Draft 100G SR4 TDP Update

John Petrilla: Avago Technologies
December 2013

Presentation Summary

100G 100m SR4: Transition time & RIN₁₂OMA tradeoff set TP2 contours

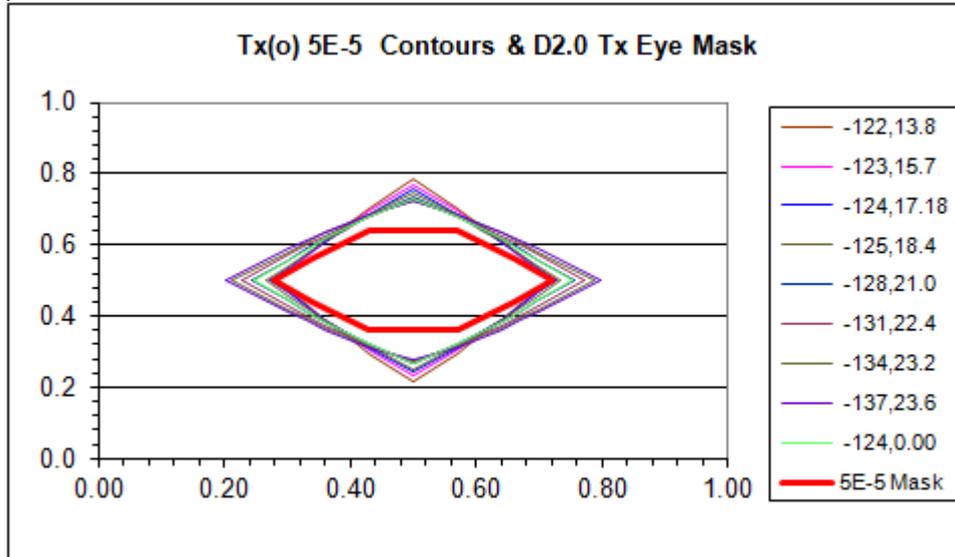
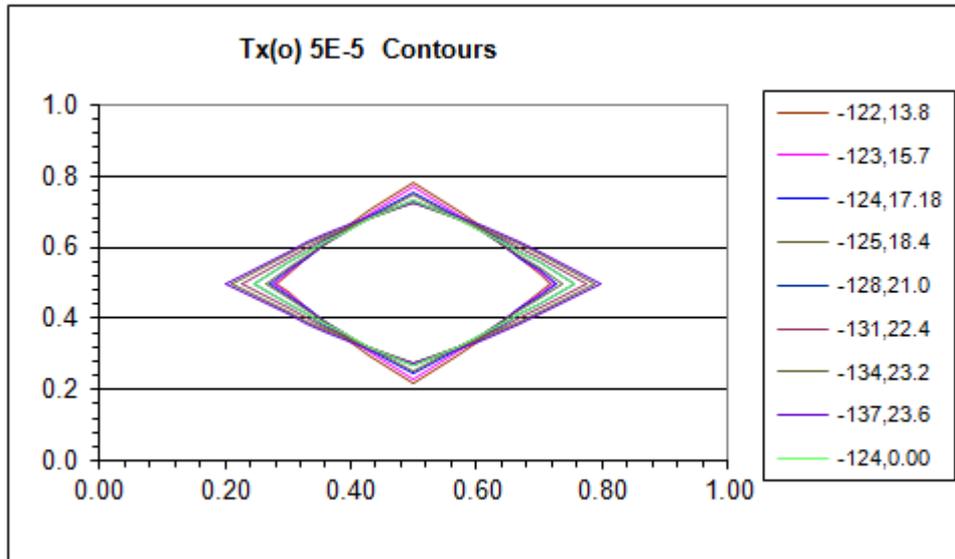
- **The currently defined (draft 2.0) Tx eye mask is included in the bottom chart. It should be adjusted so that otherwise compliant transmitters are not rejected.**

100G 100m SR4: A metric to replace TDP 2

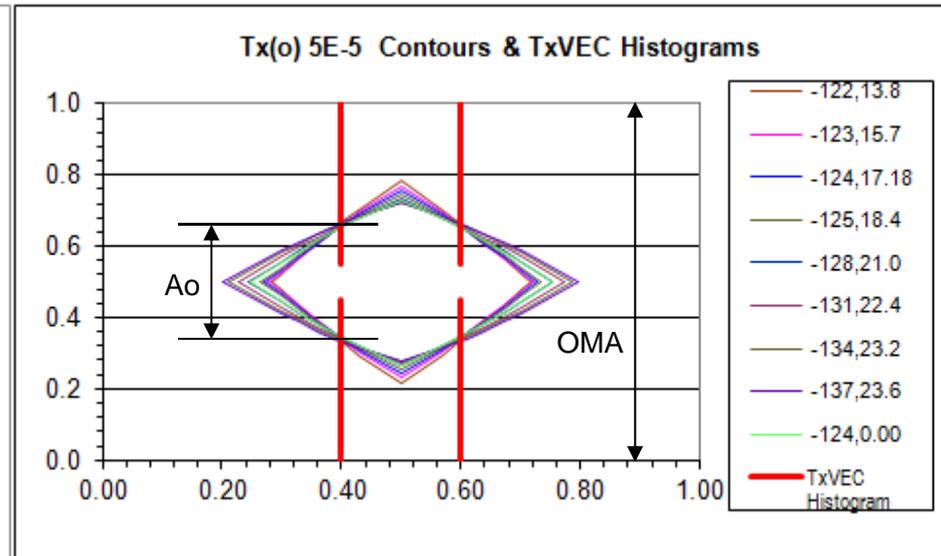
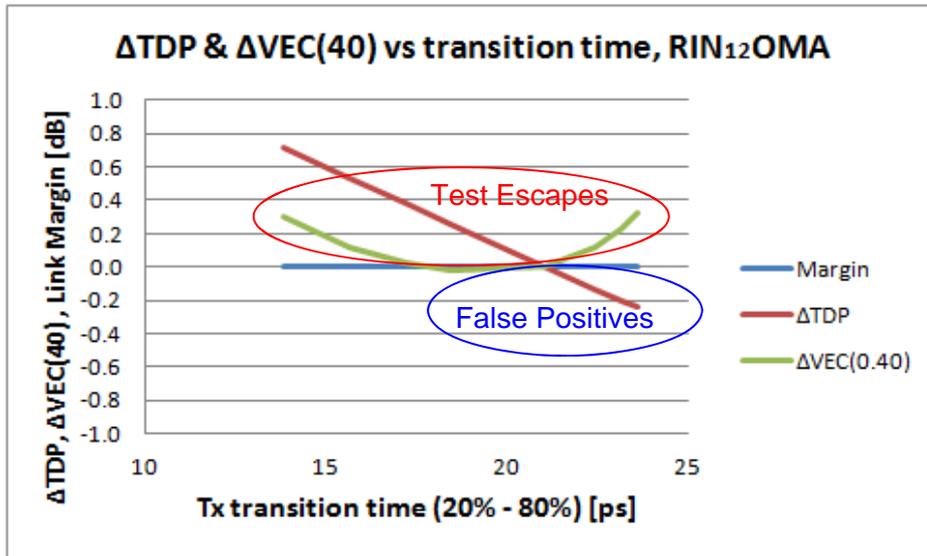
- Based on the new metric TxVEC, in Draft 2.0 replace
 - in Table 95-6, Transmitter and dispersion penalty (TDP), each lane (max) = 5 dB
with Transmitter vertical eye closure, each lane (max) = 5.1 dB
 - in Table 95-6, Launch power in OMA minus TDP (min) = -8 dB
with Launch power in OMA minus TxVEC (min) = -8.1 dB
 - in Table 95-6, footnote b, Even if the TDP < 0.9 dB, the OMA (min) must exceed this value.
with Even if the TDP < 0.9 dB, the OMA (min) must exceed this value.
 - in Table 95-8, Power budget (for max TDP) = 8.2 dB
with Power budget (for max TxVEC) = 8.2 dB
 - in Table 95-8, Allocation for penalties (for max TDP) = 6.3 dB
with Allocation for penalties (for max TxVEC) = 6.3 dB

100G 100m SR4: Transition time & RIN₁₂OMA tradeoff set TP3 contours

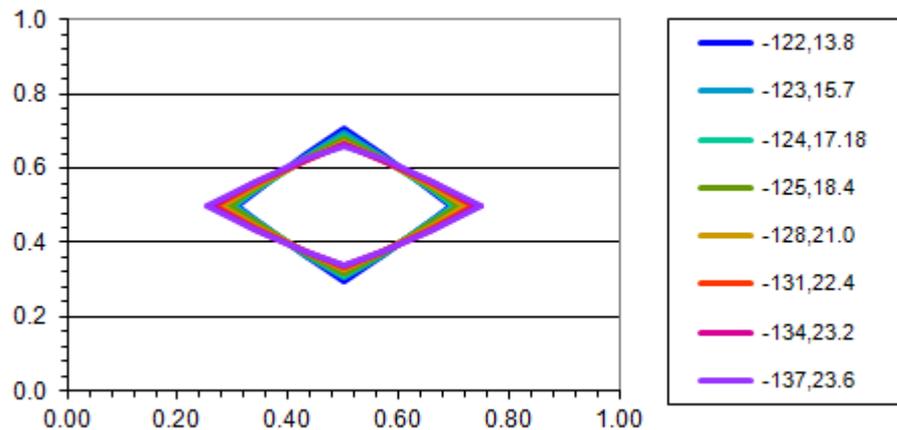
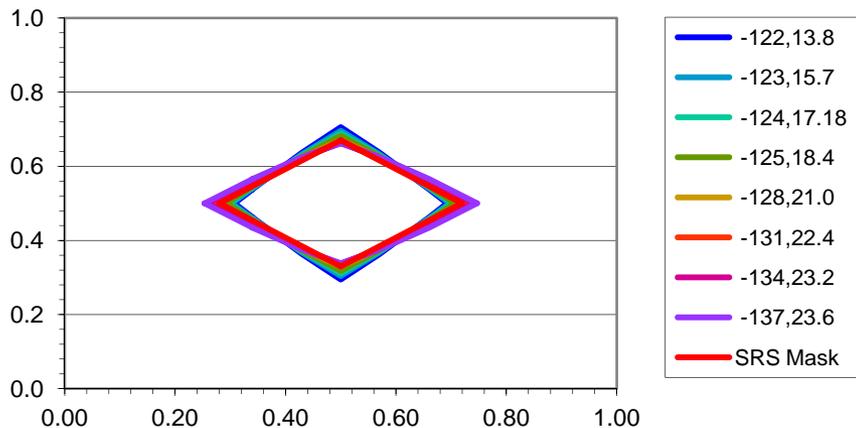
- The currently defined (draft 2.0) SRS eye mask is included for reference in the bottom chart. Since it captures one of several apparently equivalent worst case TP3 eyes, it may be acceptable as is.

100G 100m SR4: Transition time & RIN₁₂OMA tradeoff set TP2 contours

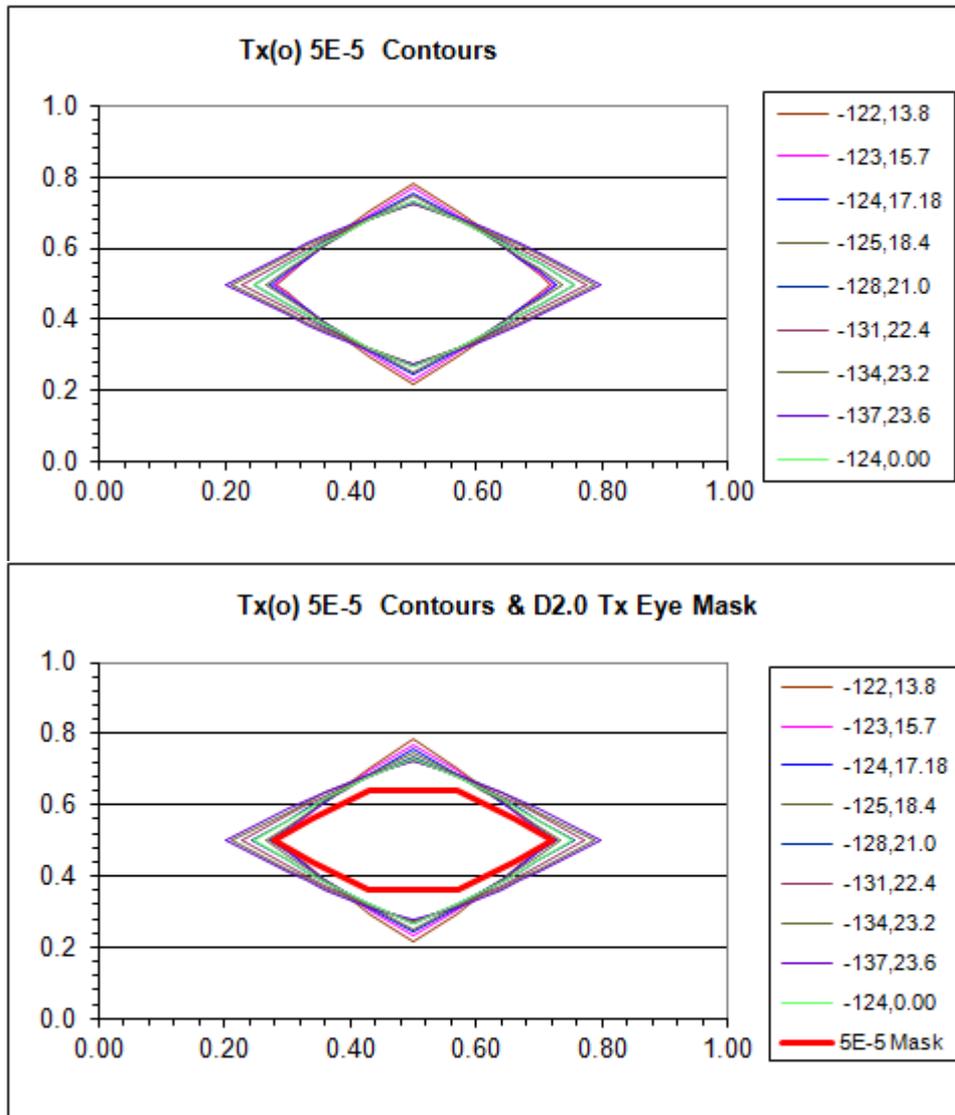
- The currently defined (draft 2.0) Tx eye mask is included in the bottom chart. It should be adjusted so that otherwise compliant transmitters are not rejected.
